DECISION OF THE PLANNING ADMINISTRATOR

**SUBDIVISION TENTATIVE PLAN / URBAN GROWTH PRELIMINARY
DECLARATION / CLASS 3 SITE PLAN REVIEW / CLASS 2 ADJUSTMENT /
TREE VARIANCE / CLASS 1 DESIGN REVIEW CASE NO.: SUB-UGA-SPR-ADJ-
TRV-DR23-02**

SUMMARY: A proposed six-lot subdivision for Titan Hill Estates in conjunction with a proposed multi-family development of 436 units for Titan Hill Apartments.

APPLICANT: Brandie Dalton, Multi-Tech Engineering Services Inc. on behalf of Titan Hill Property LLC (Kelly Hamilton)

SDR3

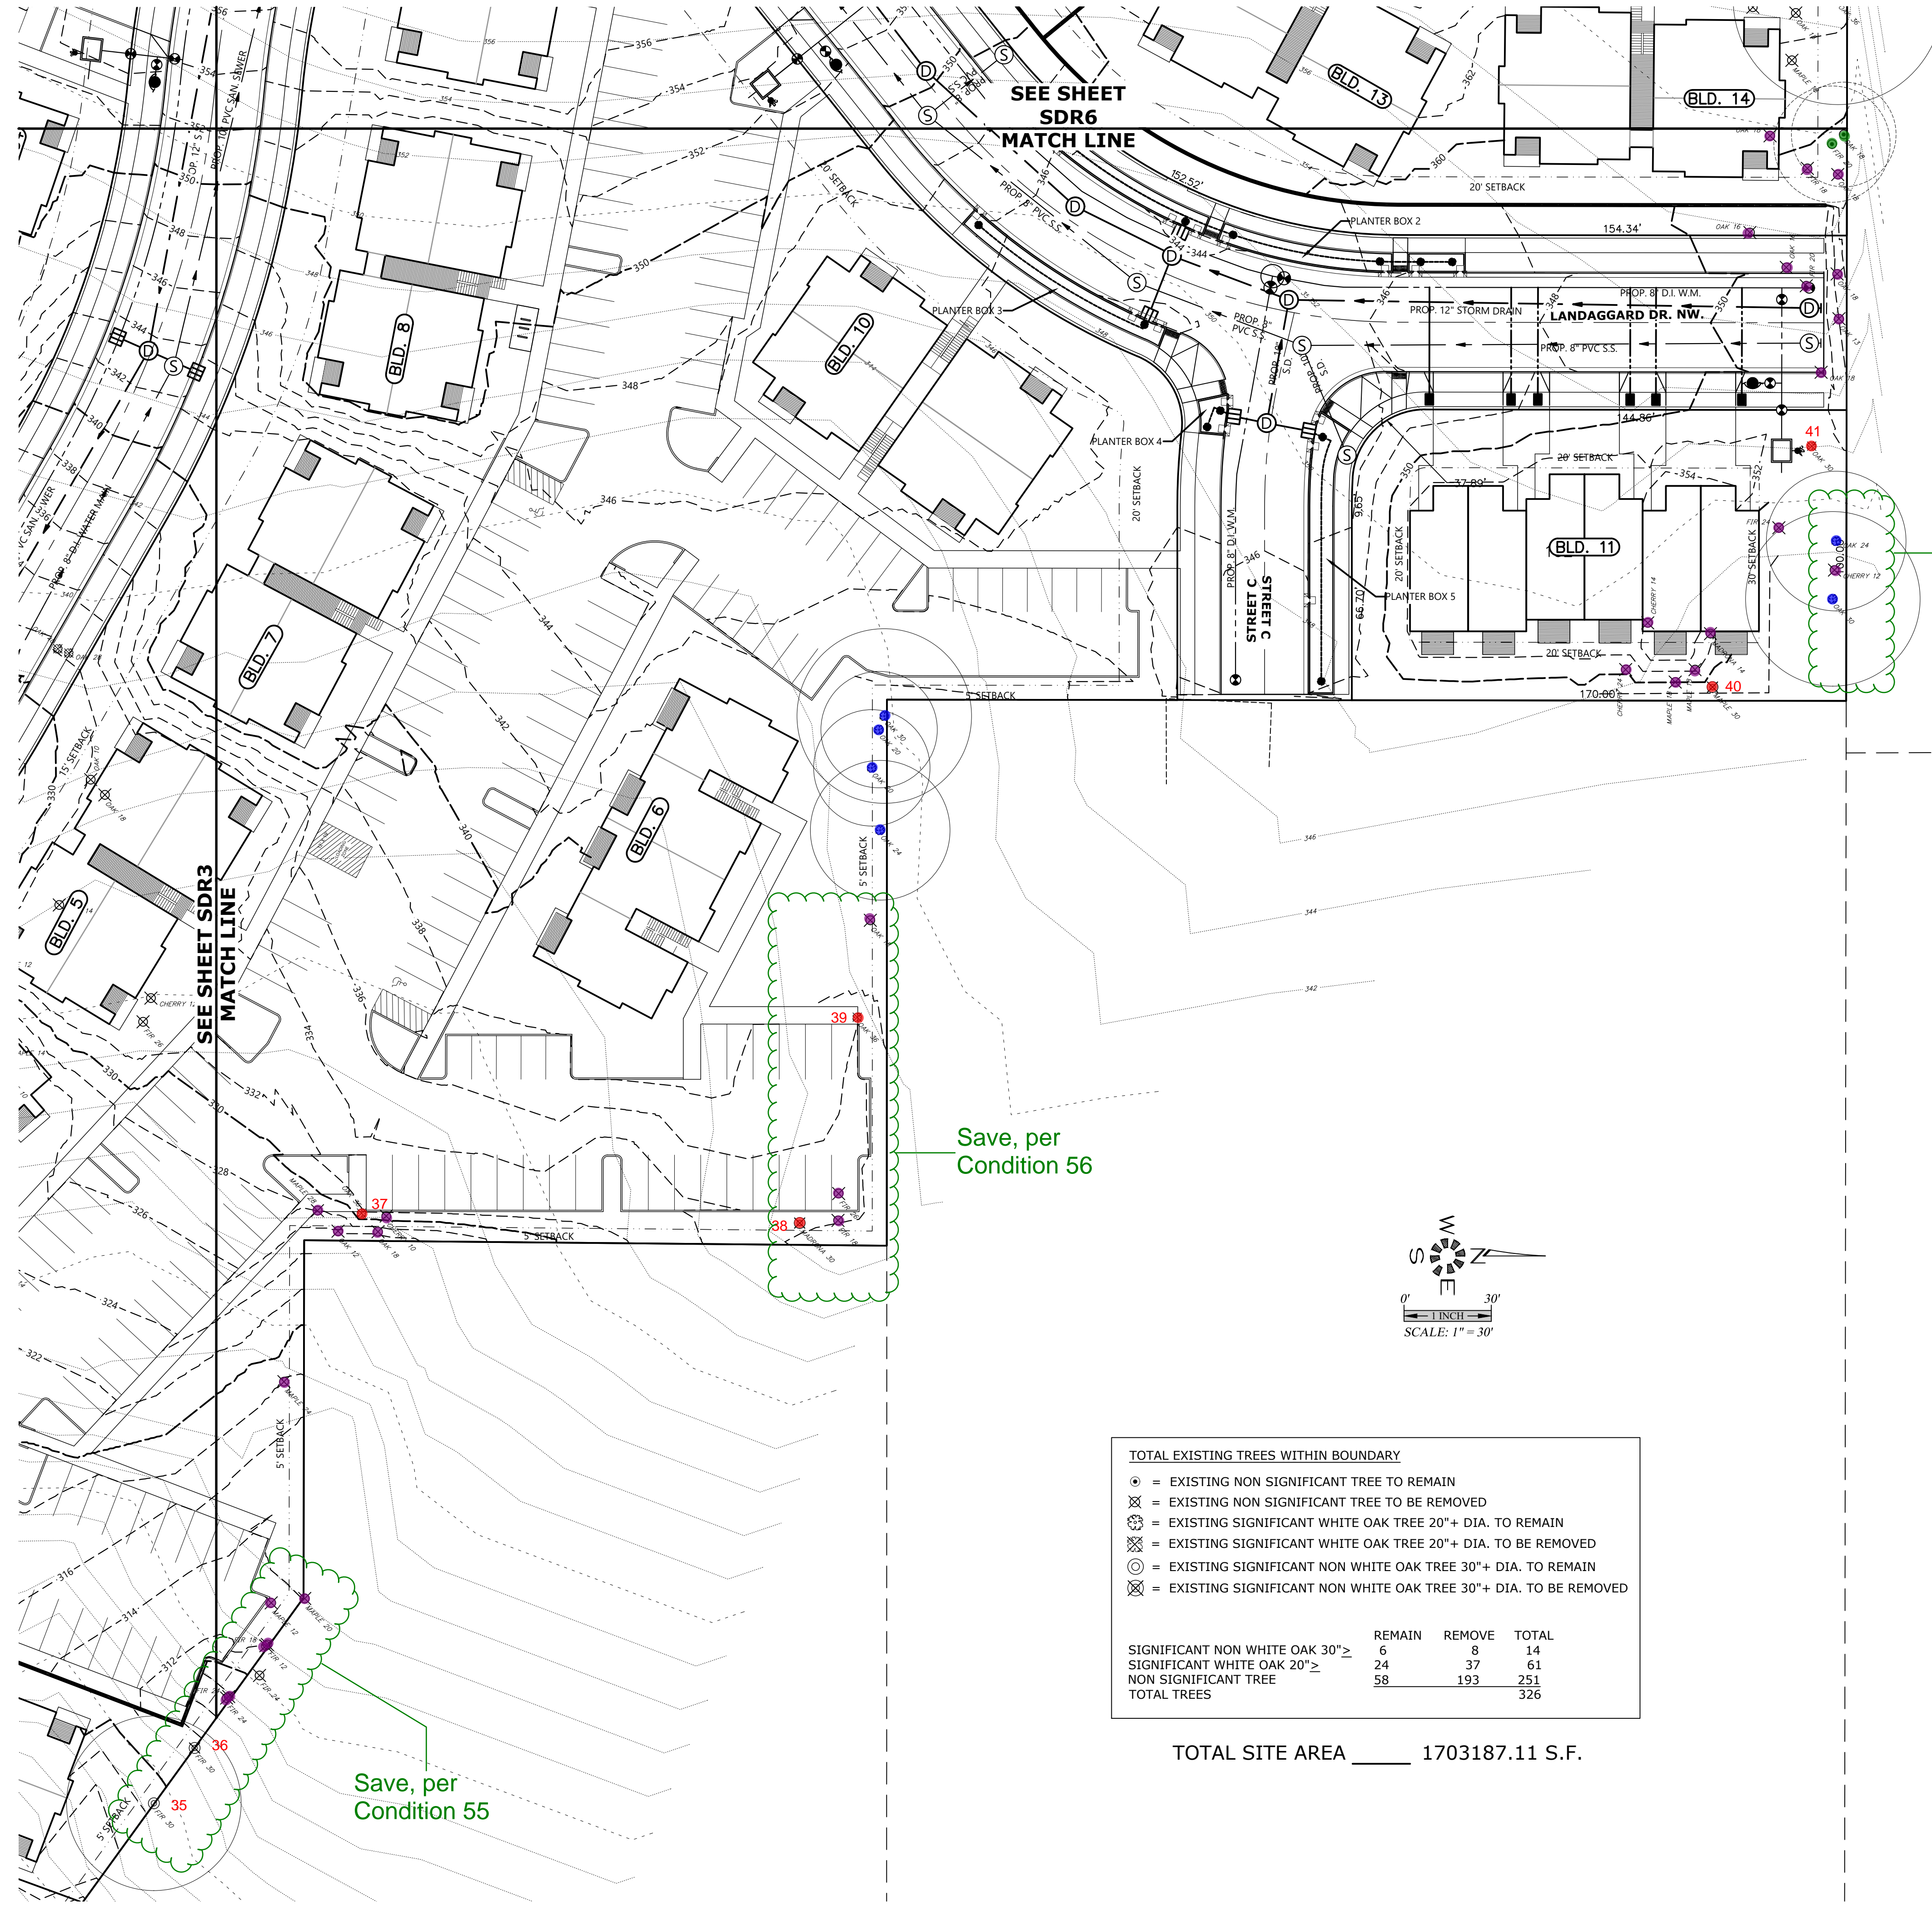
Save, per Condition 55

SDR6

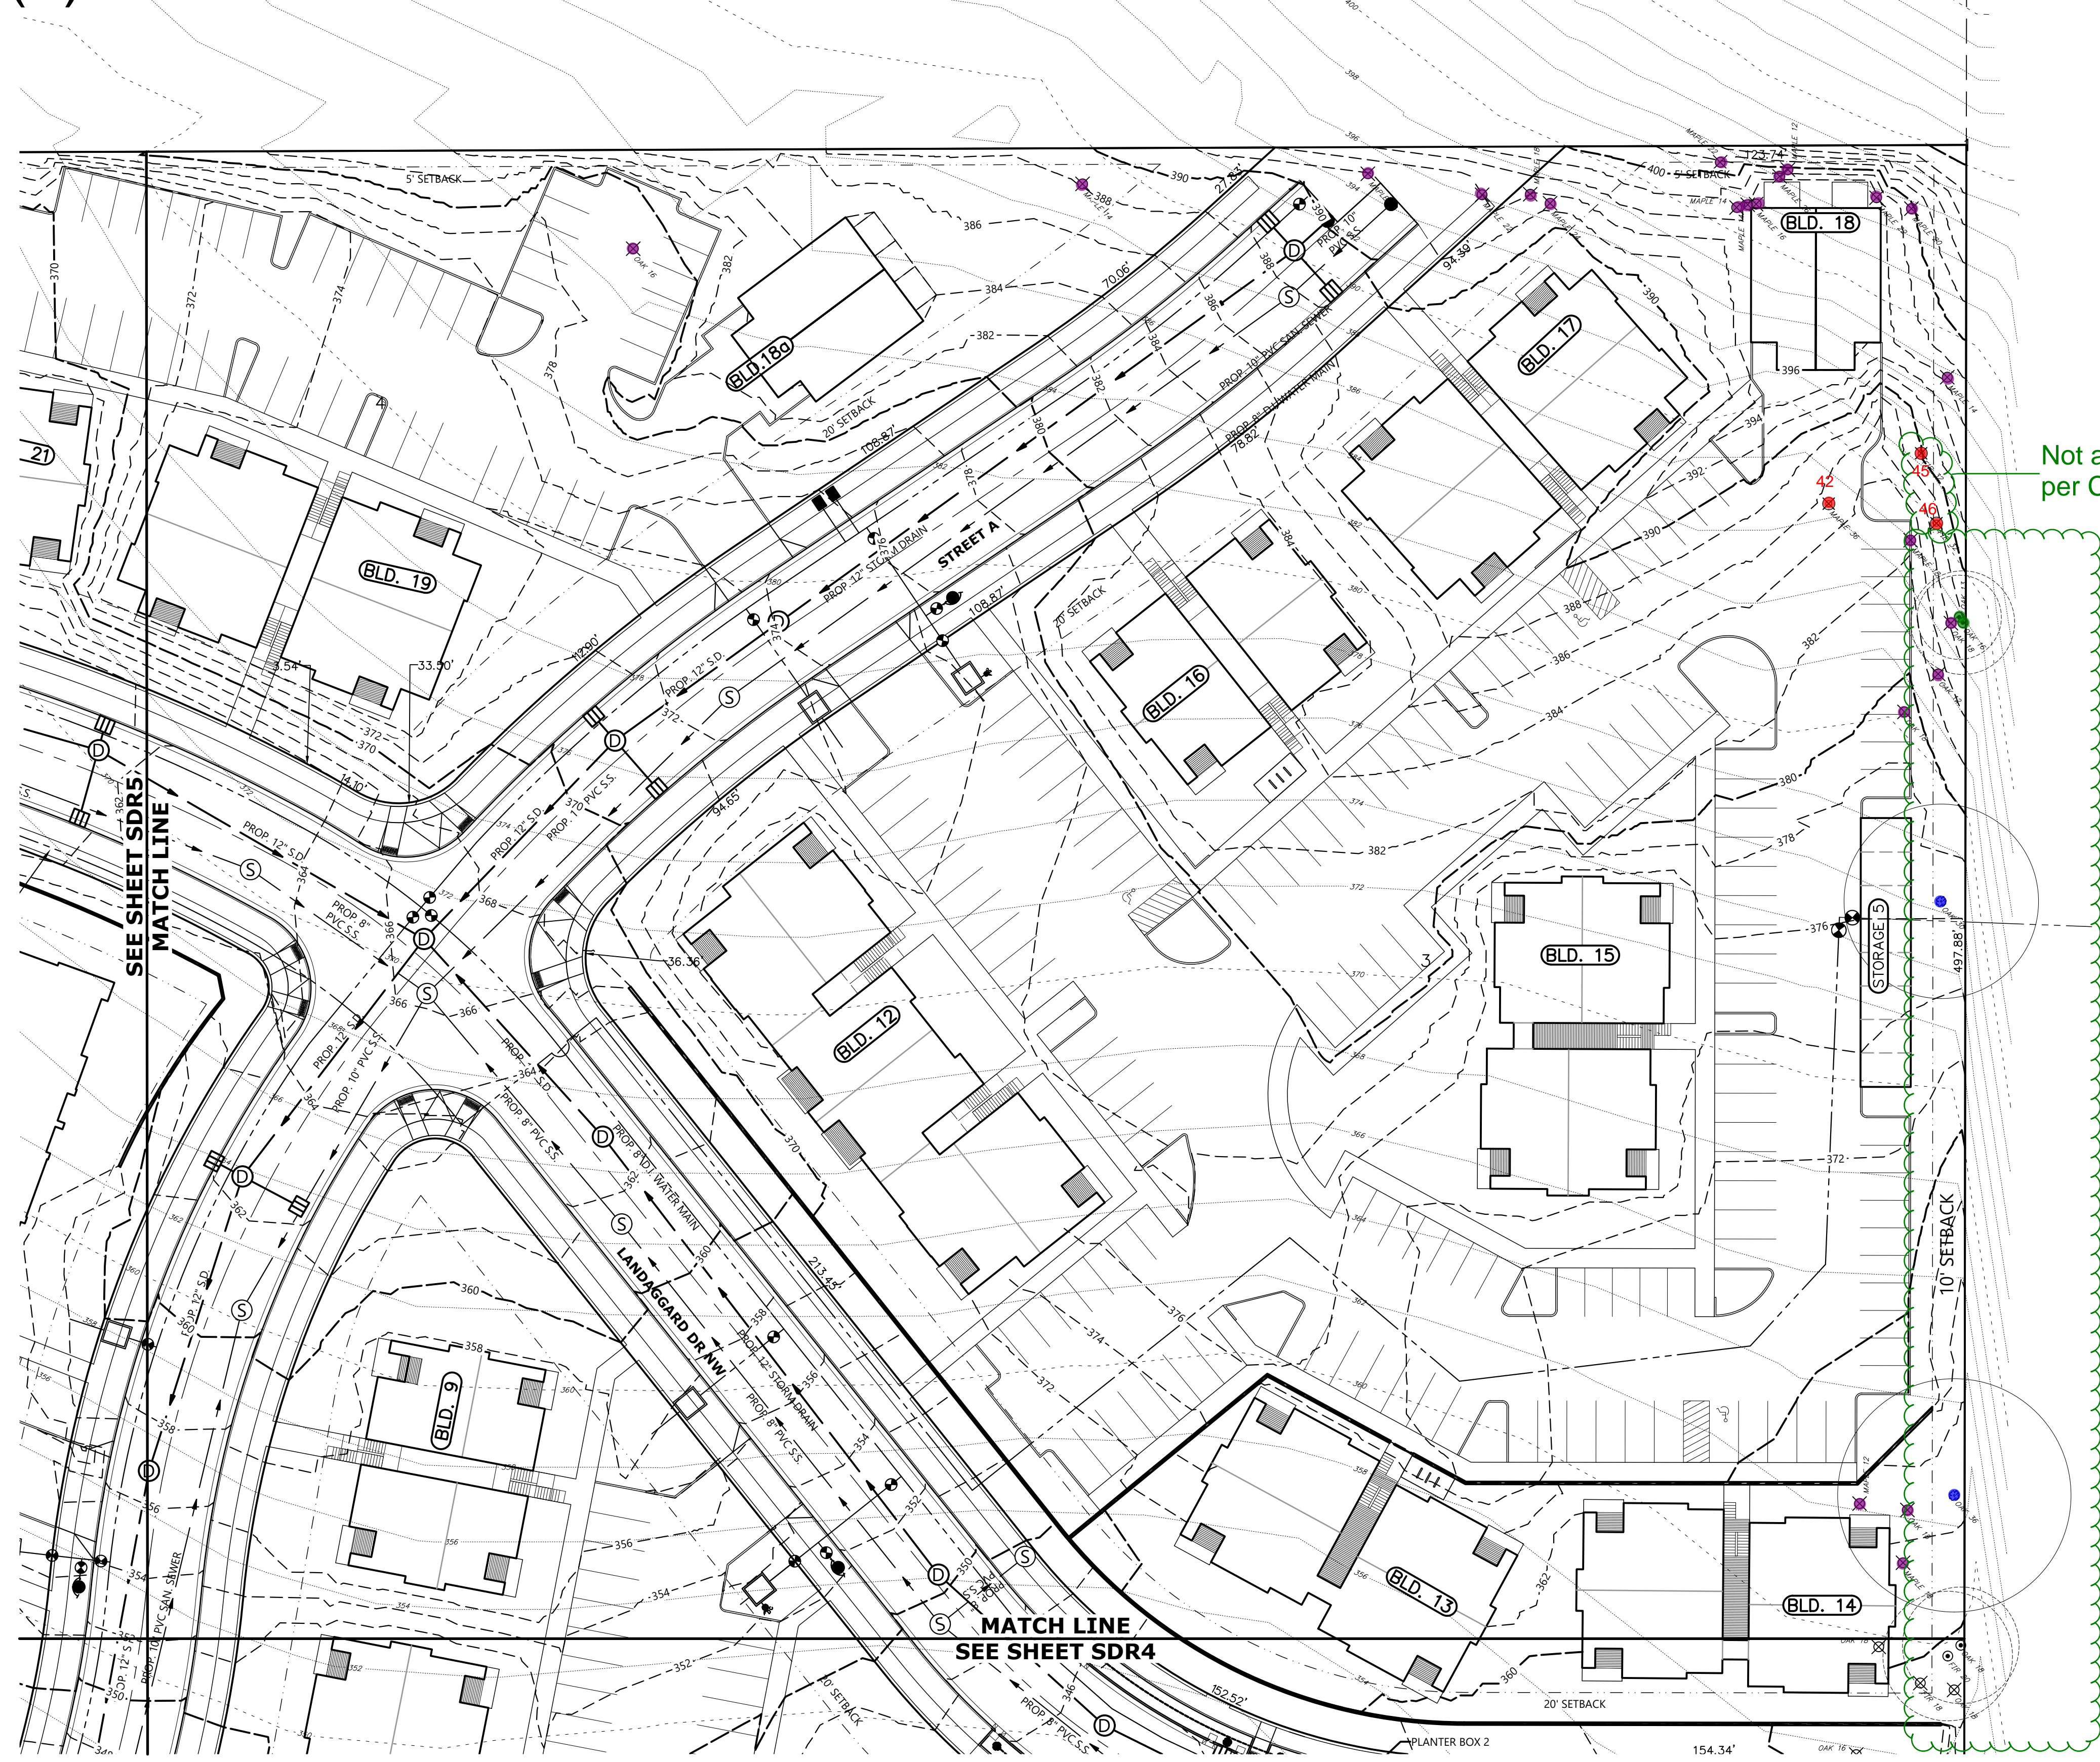
Not addressed - Save, per Condition 52
